Notice of power-supply device for brake change (Saddle and Gear motor for crane saddle(SGM))

SUBJECT	Notice of power-supply device change for brake (Saddle・SGM)	Date of issue	Apr 15, 2013	Notified to
		MITSUBISHI ELECTRIC FA INDUSTRIAL PRODUCTS CORPORATION 1-1-1 Imajuku-Higashi, Nishi-ku, Fukuoka 819-0192 TEL 092-805-3400		Sales agent

No. 855-0248

• Referential example for a change in outline drawing

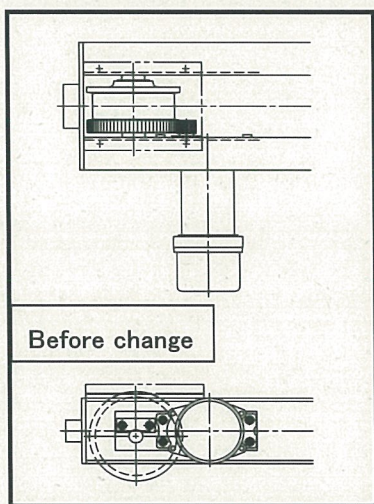
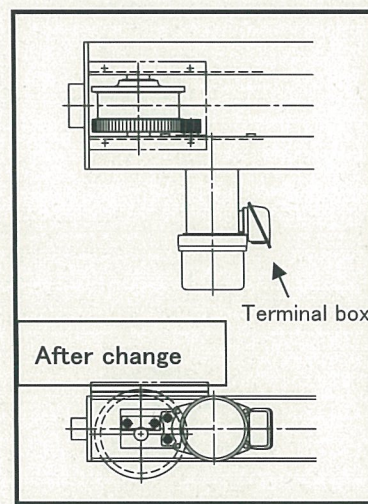
(The terminal box is attached for the models which were not previously equipped with terminal box.
please refer to the catalogue for details)
